Service Bulletin

Bulletin Number: **SB-21-351-WM**
Release Date: **September 17, 2021**
Distribution: **Waste Management Managers, Heil Dealers, Heil Technical Services, Heil Customer Care**
Subject: **Half/Pack® and Half/Pack® (Featuring Odyssey® Controls): Front Head Manifold Hydraulic Tube Failures and Body Controller Program Update to Smooth Packer Operation**

Figure 1. Upper Front Head Enclosure and Connecting Hardware (Red Circles)

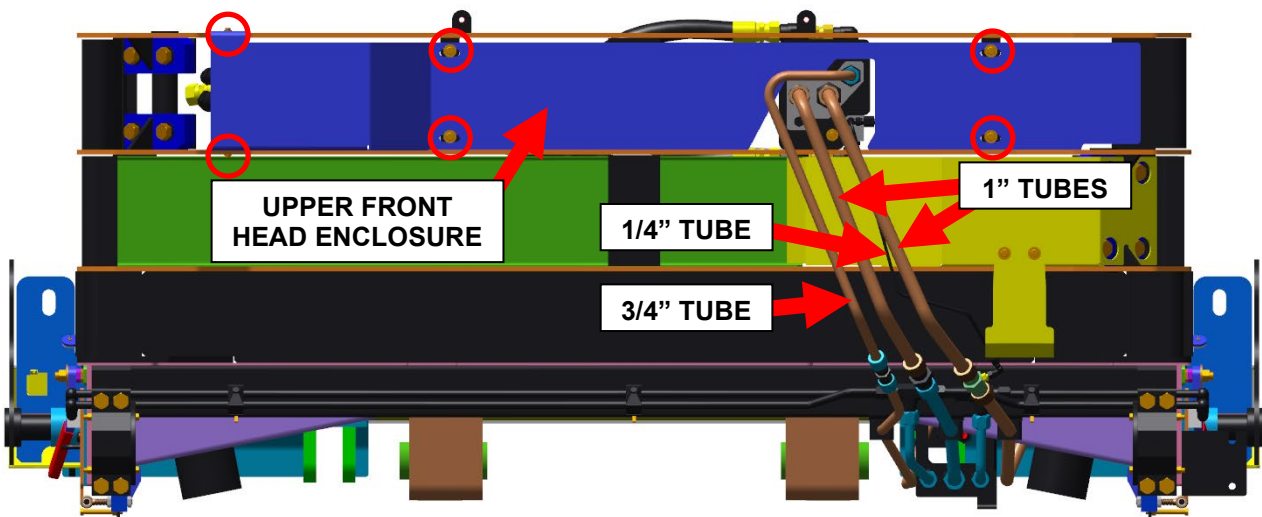
- (1) Make sure that the work area and affected area on the unit is thoroughly cleaned to prevent hydraulic system contamination.
- (2) Position a container to catch the hydraulic oil that might be released from hydraulic connections when loosened.
- (3) Remove the six (6) bolts and associated hardware from the upper front head enclosure. Set upper front head enclosure and associated hardware aside for reuse later. See **Figure 1**.

- (4) Detach the one (1) 3/4" front head manifold tube and set aside for reuse later. See **Figure 1**.
- (5) Detach the two (2) 1" front head manifold tubes and set aside for reuse later. See **Figure 1**.
- (6) Detach the one (1) 1/4" front head manifold tube and set aside for reuse later. See **Figure 1**.

Figure A. Example of "Bad" and "Good" Tube Flares

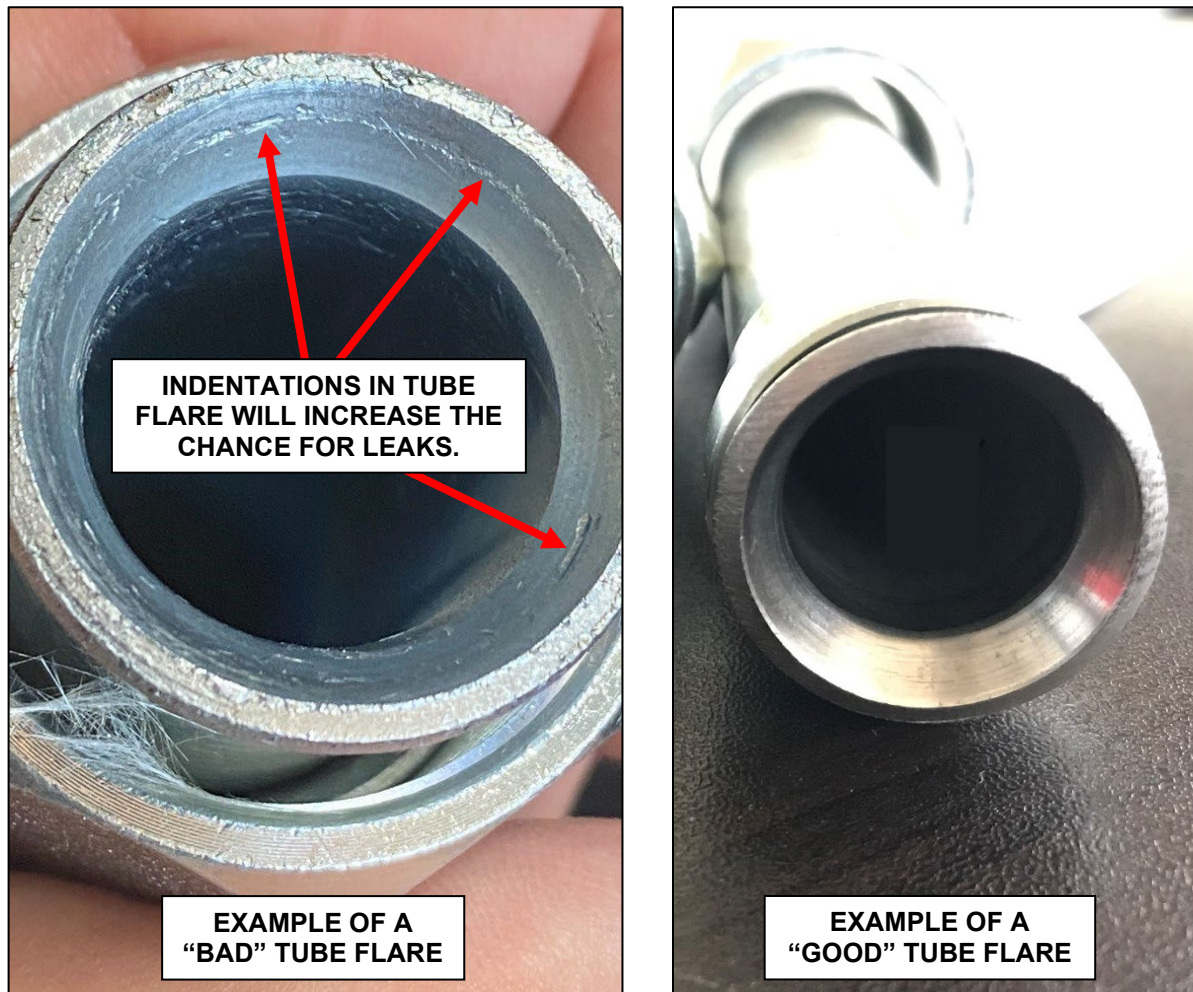
Visually inspect the tubes to be reinstalled. The tube flares must not show damage or manufacturing defects, including scratches, scoring or indentations. If indentations are found in tube flares, do not install them, and contact Heil Technical Service at 866.310.4345.

Figure 3. Front Head Tube Support Clamp Installation Location (Thermal Resistant Sleeves not Shown)

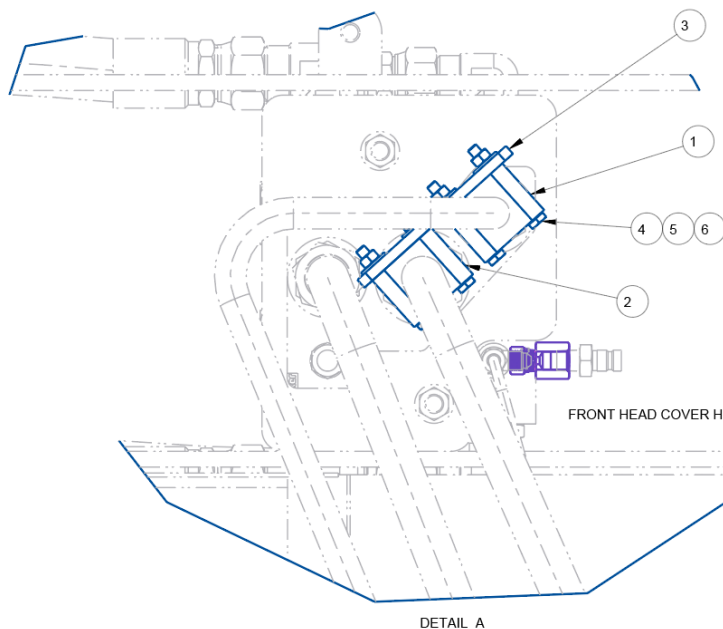
- (1) Enter the body through the hopper side door.
- (2) Install the Front Head Tube Support Clamp (311-6886) as shown in **Figure 4**.
 - (a) When installing Clamps (036-1597-005 and 036-1597-007), remove the metal base plate. Front Head Tube Clamp Bracket (311-6886) is used in its place. Replace existing hardware in clamp assembly with hardware show in **Figure 4**.
 - (b) Install the 3/4" and 1" tube clamps over the thermal resistant sleeves. The sleeve must cover the tube nut at the manifold. For the unclamped 1" tube at the manifold, zip tie the sleeve at the manifold tube nut.
- (3) Exit the body through the hopper side door.
